FINAL PLAT
DORE ADDITION
SEDGWICK COUNTY, KANSAS
2001

RE: SUB 2001-85 -- One-Step Final Plat of Dore Addition

RE: SUB 2001-85 -- One-Step Final Plat of Dore Addition

CASE NUMBER: SUB 2001-85 -- DORE ADDITION

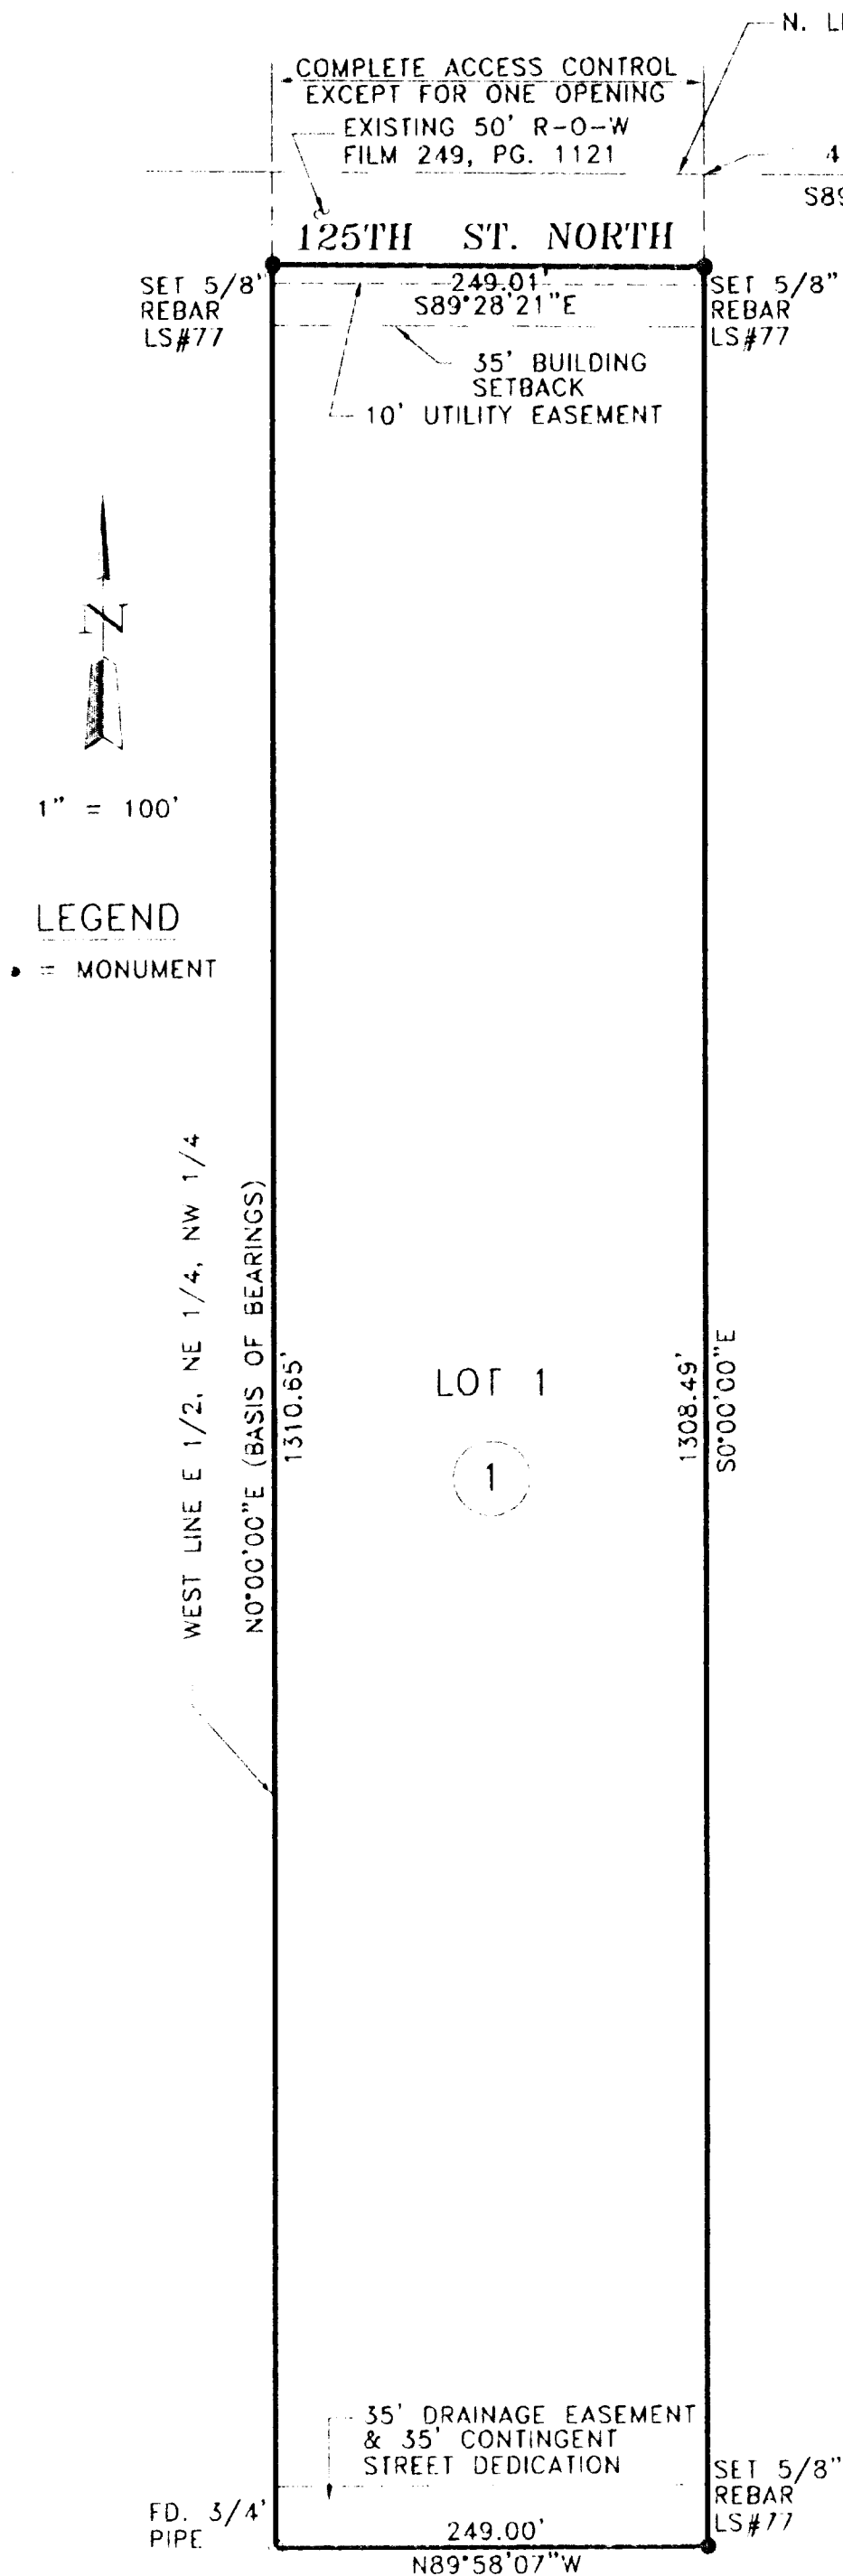
- C. **County Engineering** needs to comment on the status of the applicant's drainage plan. **A drainage plan and lot grading plan is needed.**
- D. The Applicant should provide an off-site 35-ft contingent dedication of street right-of-way along the east property line of his adjoining property to the east in order to provide potential street connection to adjoining properties. This dedication shall be established by separate instrument.

- E. The plat proposes one access opening along 125th St. North. **The Subdivision Committee has approved the access controls.**
- F. The signature line for the County Commissioners need only reference "Carolyn McGinn".

- G. The Applicant is advised that if platted, the building setback must be increased to 35 feet to conform with the Zoning setback standard for County section line roads.

- H. Approval of this plat will require a waiver of the lot depth to width ratio of the Subdivision Regulations. The Subdivision Regulations state that the maximum depth of all residential lots shall not exceed 2.5 times the width. The Subdivision Committee has approved a modification.

- I. The Applicant has provided a pipeline easement agreement which appears to indicate a blanket easement for the area involved in this plat. The Applicant shall either obtain a release of this easement or provide proof that the easement has been confined. If confined, any portion of this easement impacting this site shall be denoted on the plat and shall be properly referenced. A recorded copy of the release/confinement of the easement shall be submitted.

- K. The plat's text shall include language that a drainage plan has been developed for the plat and that all drainage easements, rights-of-way, or reserves shall remain at established grades or as modified with the approval of the applicable City or County Engineer, and unobstructed to allow for the conveyance of stormwater.

- R. Recording of the plat within thirty (30) days after approval by the City Council and/or County Commission.
- S. The representatives from the utility companies should be prepared to comment on the need for any additional utility easements to be platted on this property. Southwestern Bell has requested additional easements.
- T. The applicant is reminded that a disk shall be submitted with the final plat tracing to the Planning Department detailing this plat in digital format in AutoCAD. This will be used by the City and County GIS Department.
